Service Bulletin

Subject: Bulletin No: 05-002/16

ATF-FZ REQUIRED FOR SKYACTIV DRIVE 6-SPEED AUTOMATIC TRANSAXLE

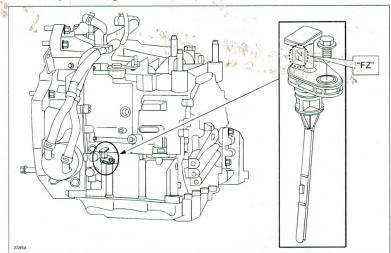
To check the fluid level, remove the bolt, then remove the dipstick. The dipstick is marked with a "FZ" on SKY-ACTIV-DRIVE FW6A-EL AT. When finished, insert the dipstick and install the bolt.

Tightening torque: 8-10 N·m (82-101 kgf·cm, 71-88 in·lbf)
